**Environmental Restoration**  
**Record of Decision**  
**Proposed Schuyler Heights Fire District**  
**Station House Site**  
**Town of Colonie, Albany County, New York**  
**Site Number E401050**

**March 2008**

**DECLARATION STATEMENT**  
**ENVIRONMENTAL RESTORATION RECORD OF DECISION**

**Detail 1: Cover System Cross Section**

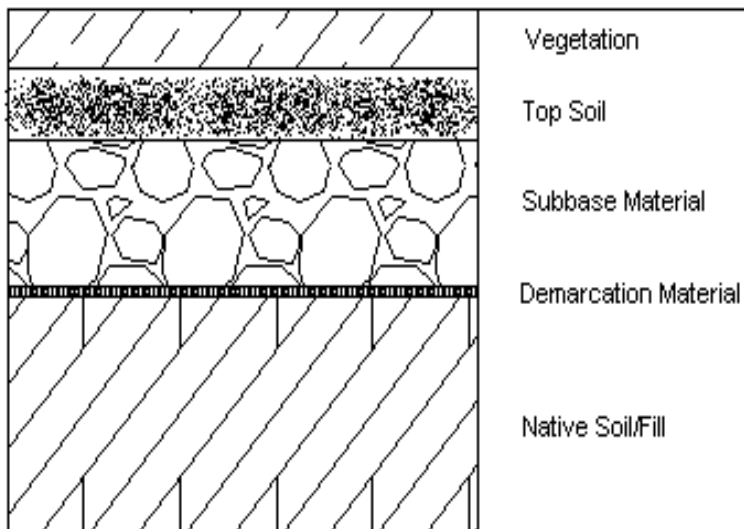
**COMMENT 5:** How thick will the cover be?

**RESPONSE 5:** As described in Section 7.1 and shown in Detail 1 of the PRAP, the soil cover system will consist of the following components starting from the bottom: a demarcation layer, a minimum of 8 inches of soil, and a minimum of 4 inches of soil capable of supporting vegetation totaling a 1-foot thick soil cover. It was also noted that asphalt, concrete, or other construction materials creating a layer not less than 6-inches in thickness and that would provide a suitable barrier cover, may be substituted for the soil cover.
